BOARD OF WATER SUPPLY

September 5, 2019

Subject: Honolulu Board of Water Supply (BWS) Comments on ABS Consulting (ABS) Report "Quantitative Risk and Vulnerability Assessment Phase 1 (Internal Events without Fire and Flooding) dated November 12, 2018" and "Navy's Risk and Vulnerability Assessment Summary" and Cover Letter dated May 29, 2019 as per Red Hill Bulk Fuel Storage Facility (RHBFSF) Administrative Order on Consent (AOC) Statement of Work (SOW) Section 8

Source: NAVFAC, 2019c – First Quarter 2019 – Quarterly Groundwater Monitoring Report, Red Hill Bulk Fuel Storage Facility, Joint Base Pearl Harbor-Hickam, Oahu, Hawaii. May.

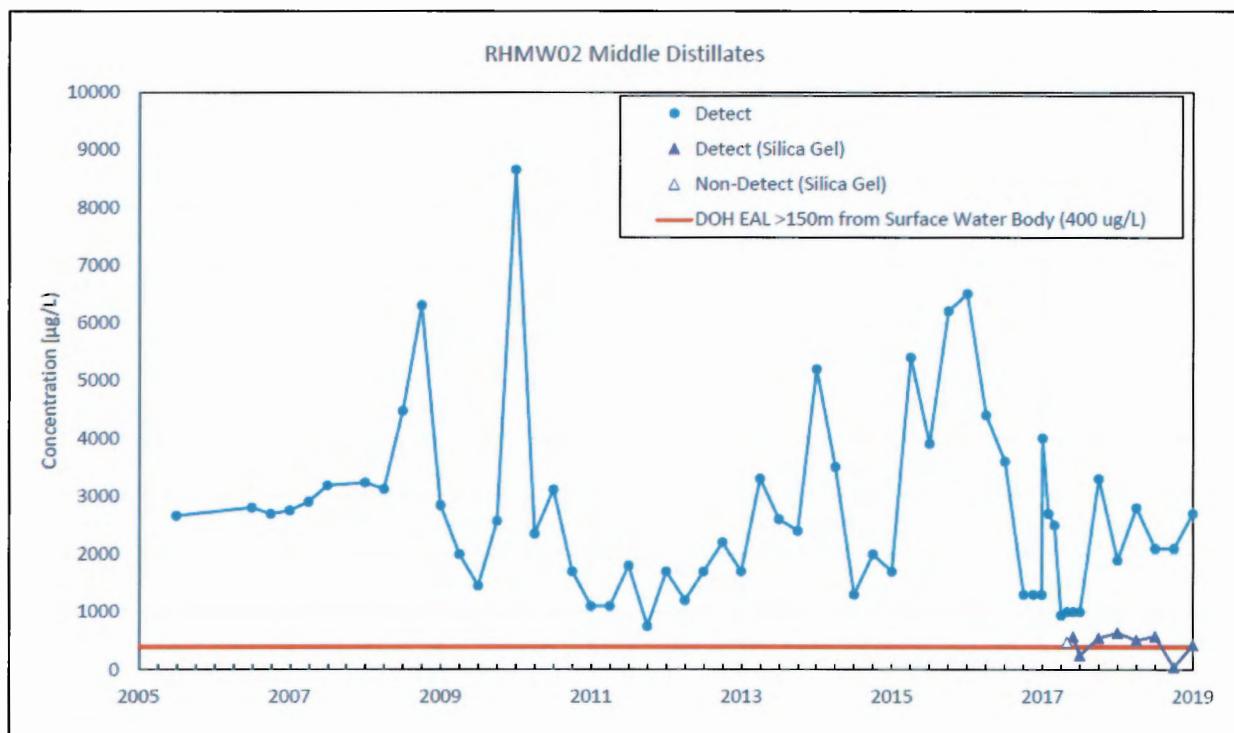
Groundwater data indicates that fuel continues to migrate to groundwater. As shown in the graph below, fuel constituents have been identified in groundwater samples collected from monitoring well RHMW02 since 2005. RHMW02 is the monitoring well located in the approximate center of the lower access tunnel and midpoint of the RHBFSF tank farm.
